BCA Compliance Assessment Report

12 Boyle Street & 307 Sydney Road, Balgowlah

Residential development

Report no. J1069-BCA-2

Figure 2: Openings requiring protection in B4 at Lower Ground Floor level

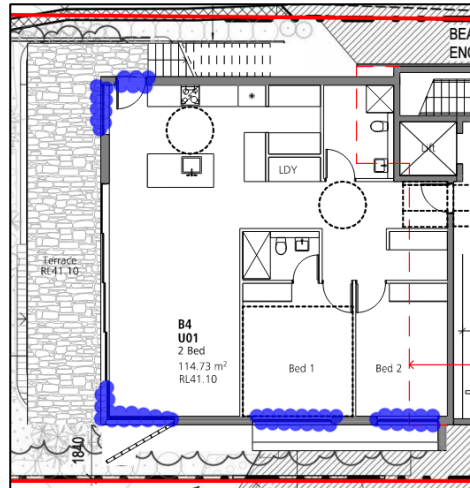
The boundary on the western side of Building 2 is located approximately 1 m from the western wall of the building. Openings in the external wall of Building 2 that are less than 1.5 m to the boundary will require protection in accordance with Clauses C3.2 & C3.4, or BCA compliance addressed by a performance solution from a suitably qualified fire engineer (registered certifier – fire safety). It is noted that the *performance solution* may permit no protection to these openings.

The openings requiring protection under Clause C3.2 are highlighted in the figures below.

Figure 5: Lift opening directly into U02 internal stair at Lower Ground level

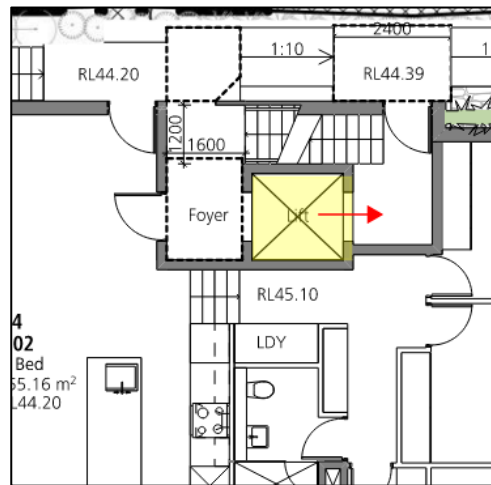
As fire rated lift doors generally achieve an FRL of –/60/- (i.e. a lift door will achieve 60 minutes integrity, but not 60 minutes for insulation), it is recommended that BCA compliance be addressed by a *performance solution* from a suitably qualified fire engineer (registered certifier – fire safety).

The lift foyer configuration of each of the affected units is shown in the figures below.

Figure 7: U02 skylight within 3 m of boundary

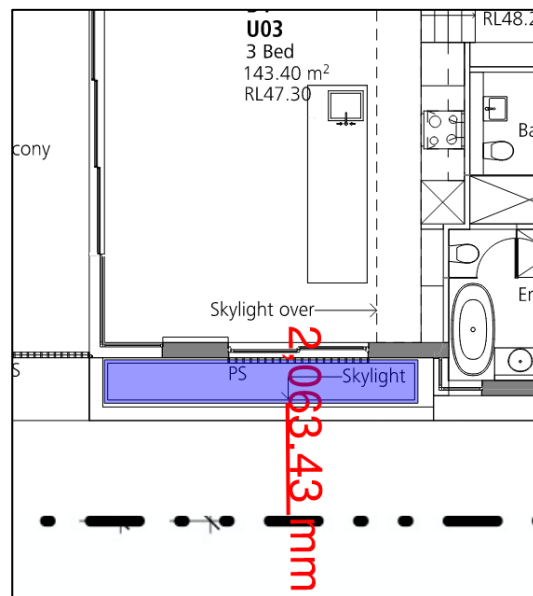
The skylight to Unit 2 in B4 is located approximately 2 m from the side allotment boundary in lieu of not less than 3 m required by this clause. It is recommended that either the skylight be removed, or BCA compliance achieved via a performance solution from a suitably qualified fire engineer (registered certifier – fire safety).

Figure 8: Natural light provision to U01 Bed 2

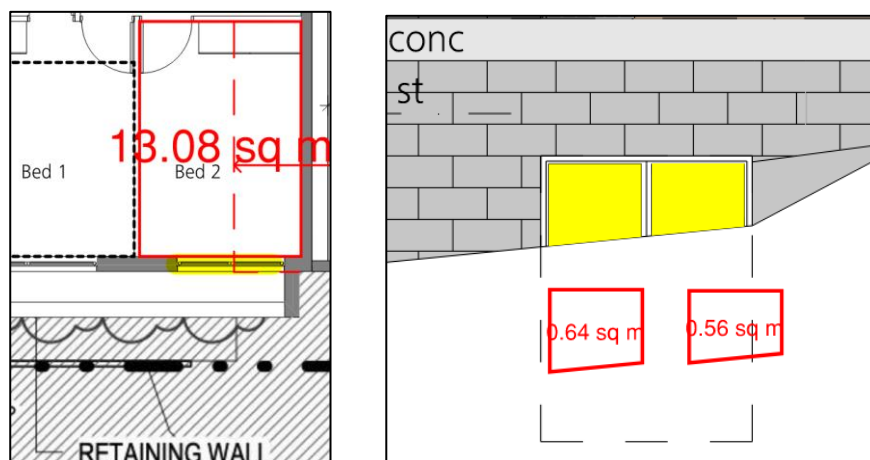
The window of Bed 2 of U01 on the lower ground level is partially screened by a retaining wall located opposite at approximately 570 mm horizontal distance from the window. To comply with Clause F4.2(b), it must be ensured that the exposed portion of the window (not screened by the retaining wall or adjoining ground) is at least 1.308 m² (i.e. not less than 10% of the floor area of the bedroom, inclusive of built in wardrobe).

Details demonstrating compliance to be provided in the Construction Certificate stage plans..
